4 Stitch Knit Composite Ltd.

21st July 2019

Observations

1st to 5th floor roof beam layout

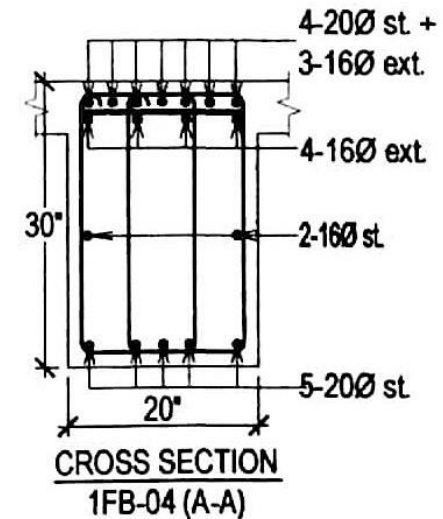
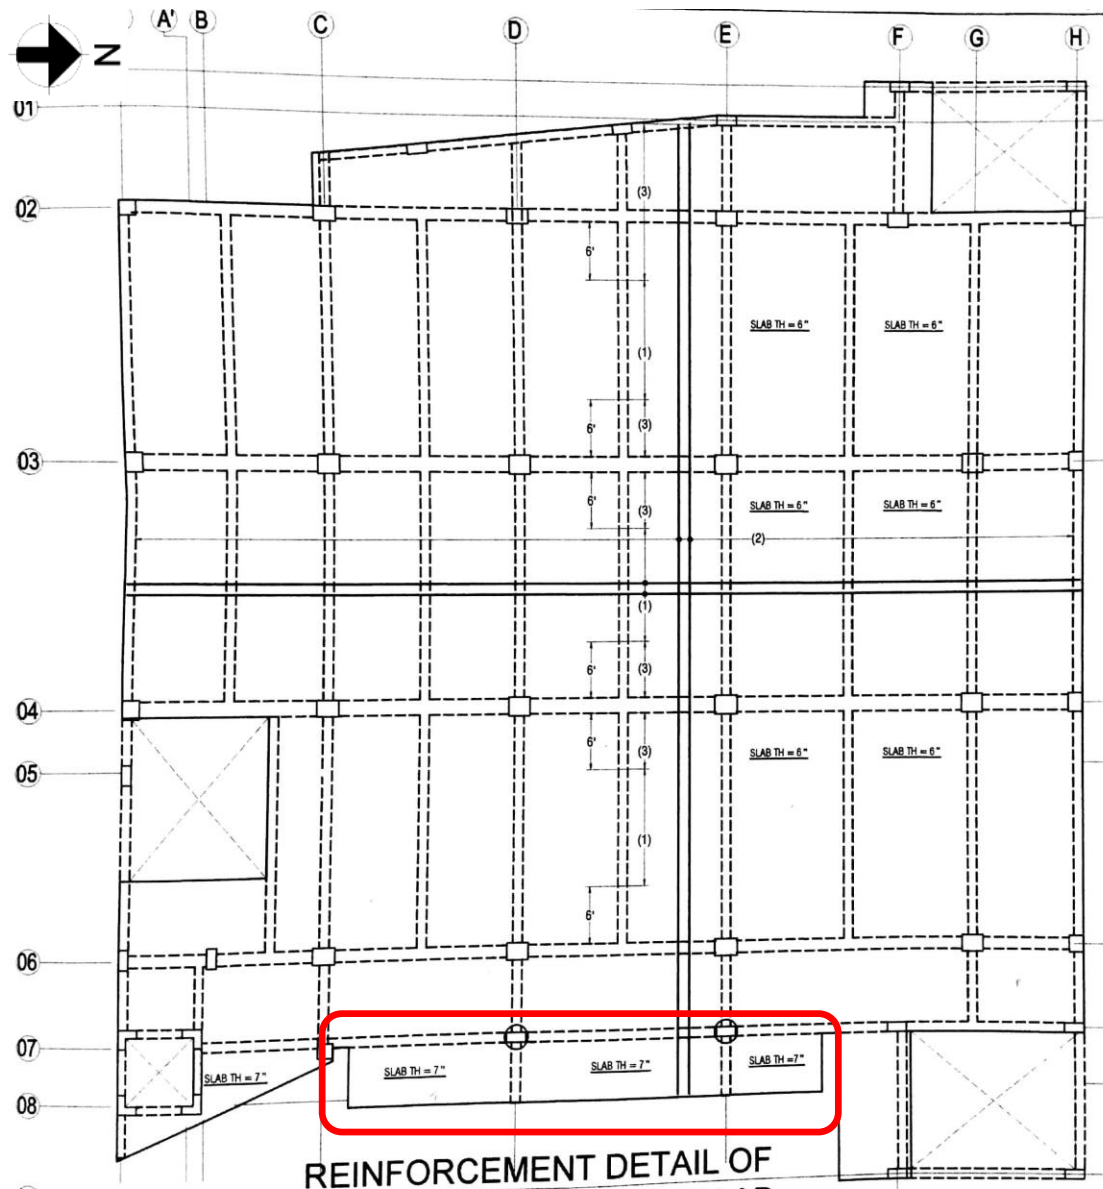
Beam width of FB-03 & FB-04 was supposed to be 20 inches as per provided as-built drawings. During inspection, beam width of FB-03 & FB-04 on 1st to 3rd floor roof was found 18 inches.

Observation: Main Building

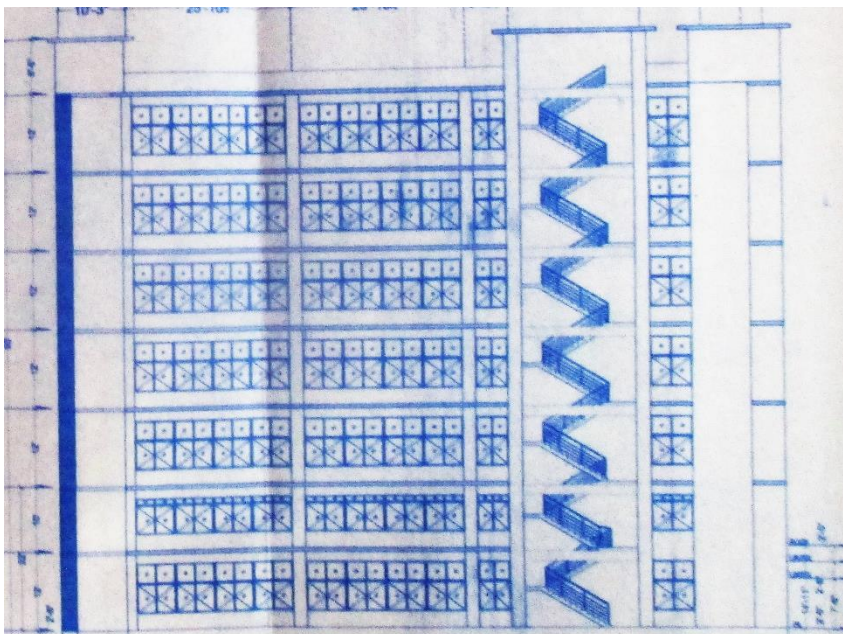
No load management programs were visible. Load plan has been prepared but not posted on floors. Factory is required to implement load management program as per produced load plans for all floors of the buildings and make sure that the workers understand the loading requirements. Also, provide load height marking in storage areas.

Possible vertical extension

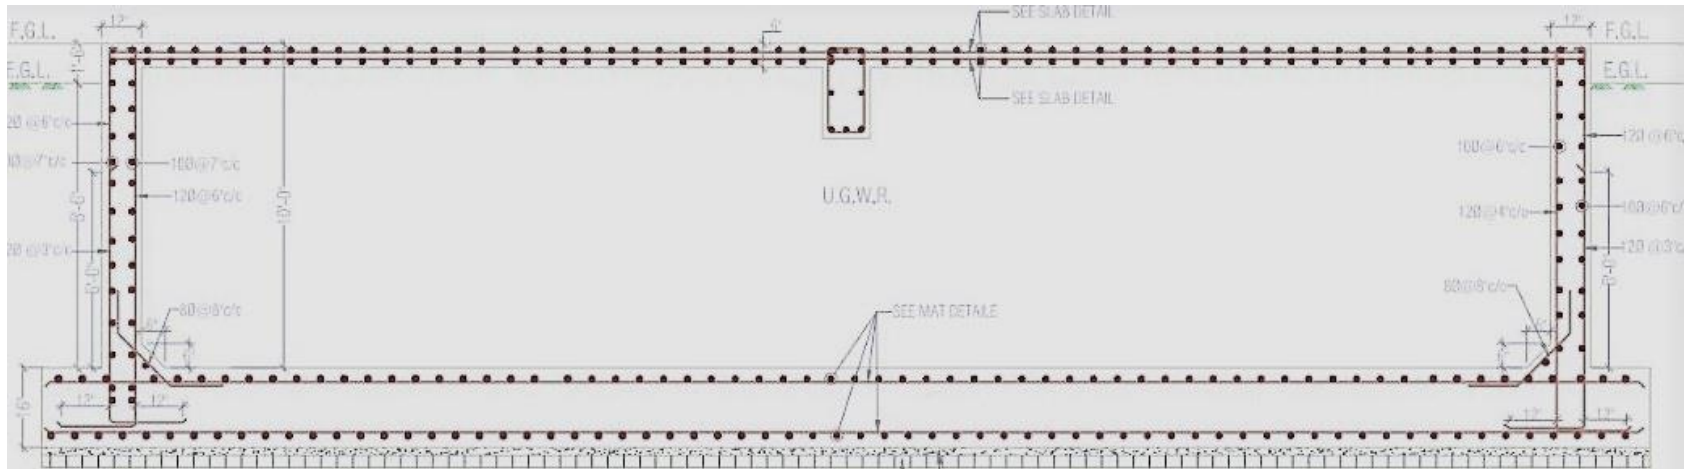
This building is permitted for 6 storied with a mezzanine (G+M+5) on the ground floor from LGED. Currently the building is 3 storied with a mezzanine. Factory has a future plan to complete construction up to 6 storeys. Proposed drawings were available during inspection. Factory engineer is required to carry out a Detail Engineering Assessment considering BNBC standard prior to any extension work.

Section of water reservoir

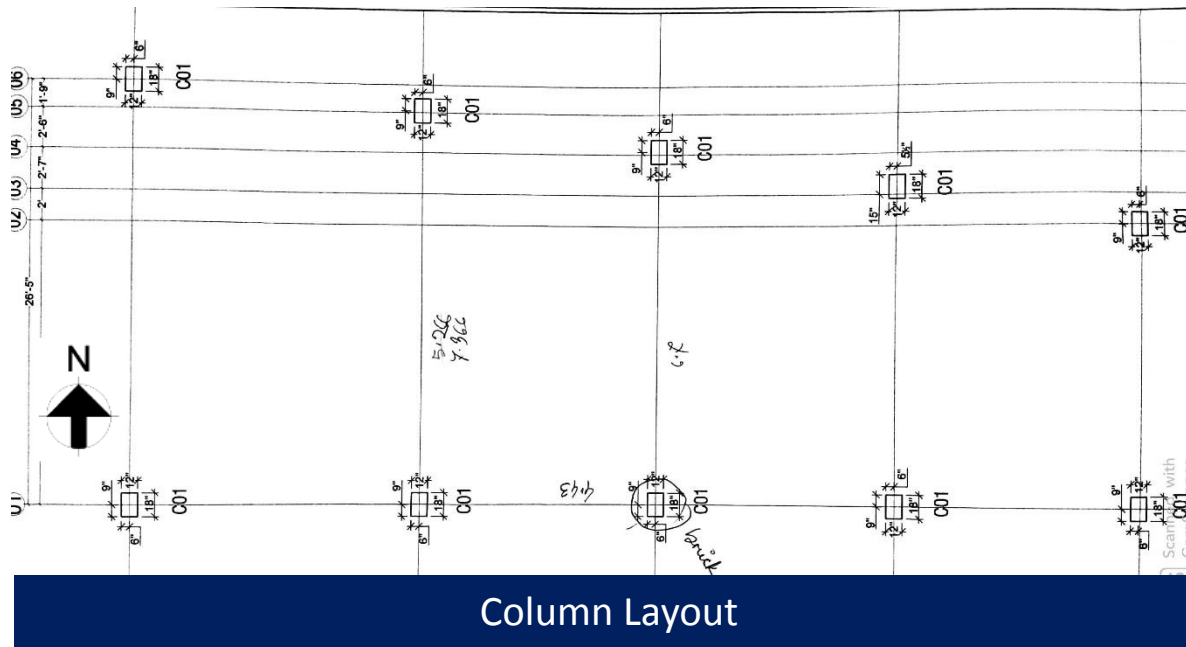
Underground Water Reservoir is situated beneath the vehicle parking and loading-unloading zone. Top slab thickness is 6 inches as per provided water reservoir drawing. Therefore, factory is required to check for adequacy of the top slab of water reservoir.

Discrepancies between provided drawing and on-site condition

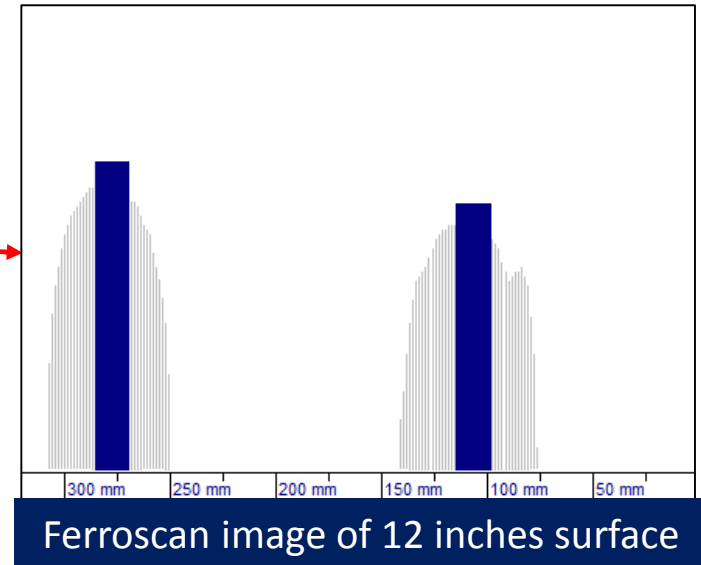
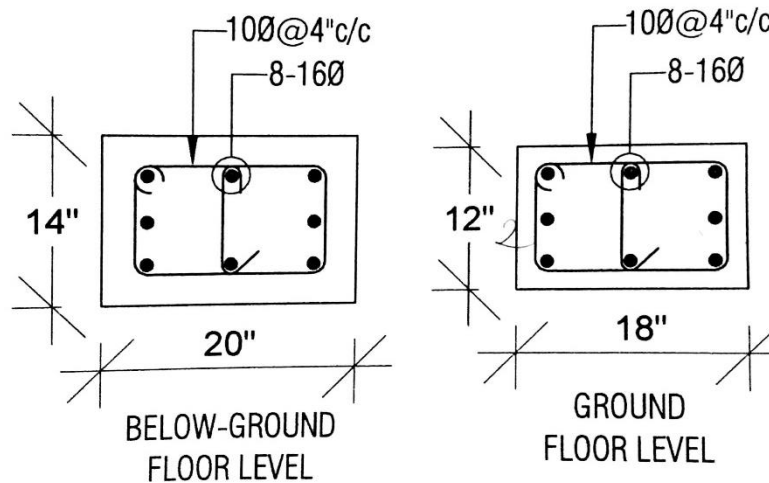
6-16 mm rebars were found in C1 type columns in stead of 8-16 mm rebars as mentioned in provided as-built structural drawing. Factory is required to update as-built drawings representing actual on-site condition.
